Site Plan Review

Saratoga Way, Lots 112 & 113

ROSS ENGINEERING, LLC

- A response letter addressing our comments from Ross, dated December 3, 2020.
- Plan set titled "Site Plan Review, Saratoga Way, Lots 112 & 113, Portsmouth, New Hampshire", prepared by Ross, and dated December 3, 2020.
- A report titled "Plan for Stormwater Management, For Property Located at: Saratoga Way, Tax Map 212, Lots 112 & 113, Portsmouth, NH 03801" prepared by Ross, dated December 3, 2020.
- A document titled "Stormwater Management Operation and Maintenance" prepared by Ross.

Sheet 8

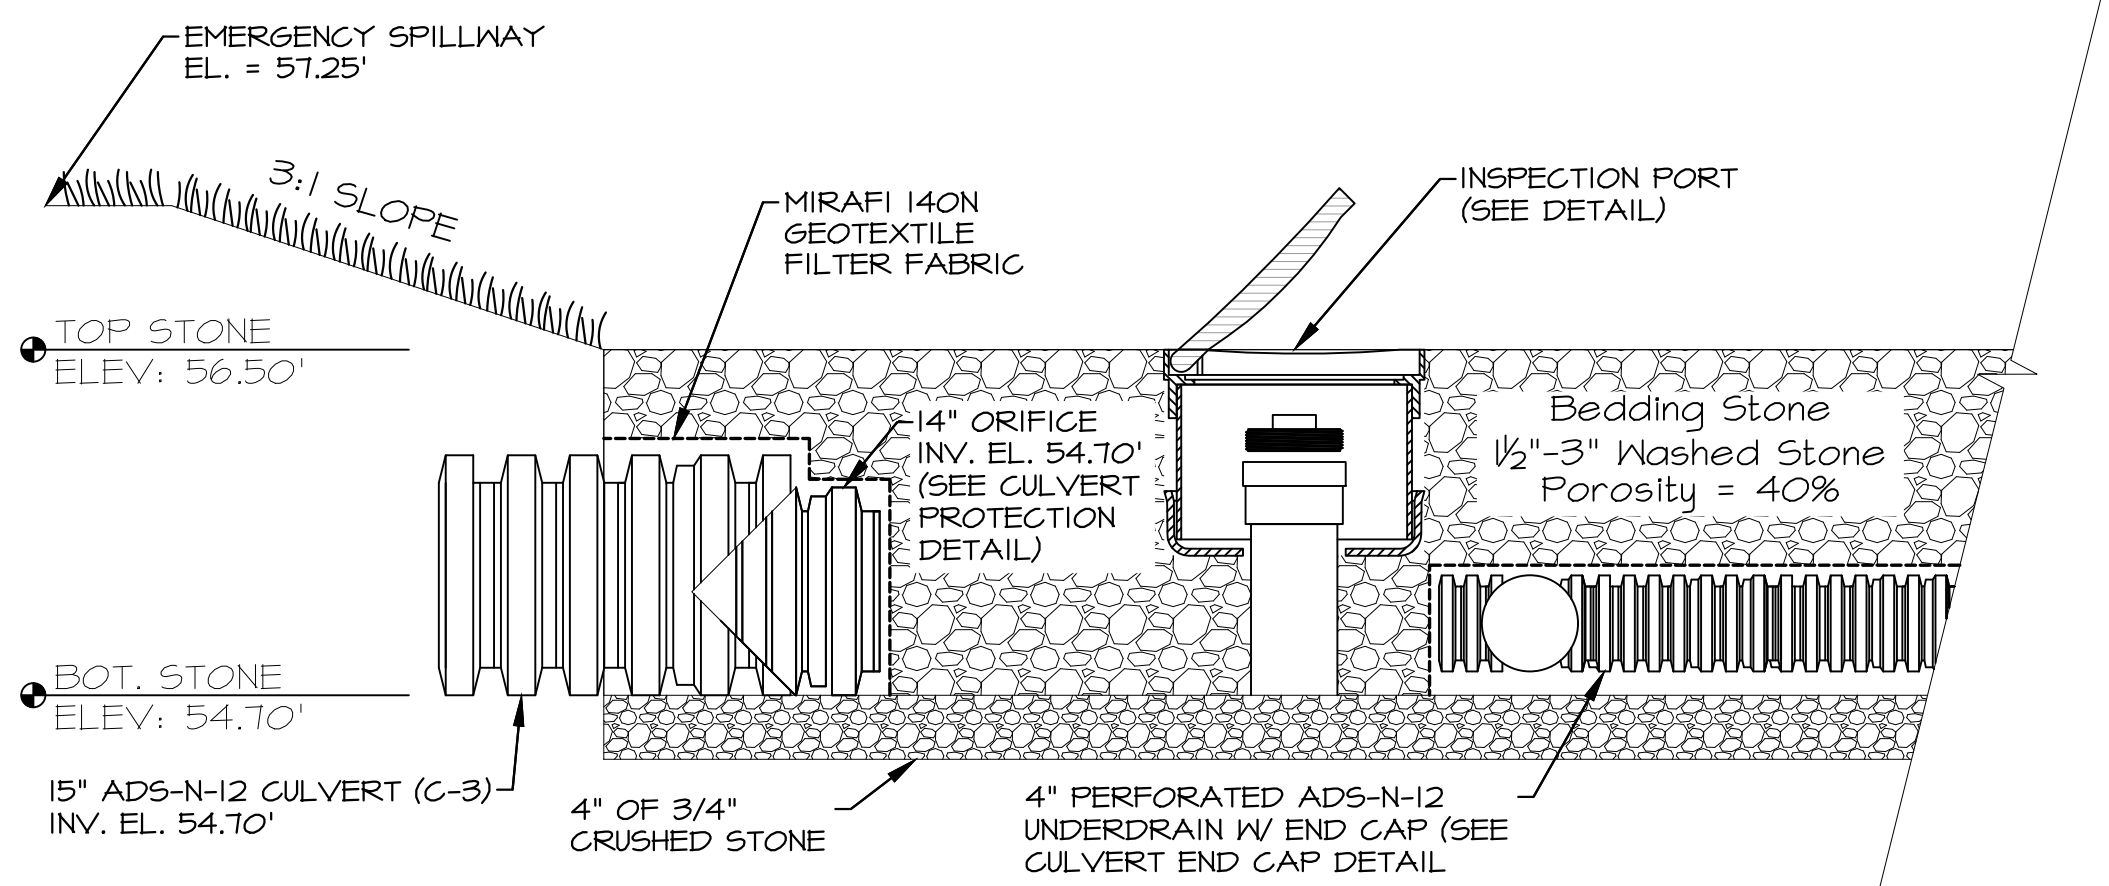
7. The infiltration trench detail should specify 4 inches minimum of stone underneath the perforated pipe.
8. The stone detention pond detail should include an inspection port to monitor the water level inside the practice.
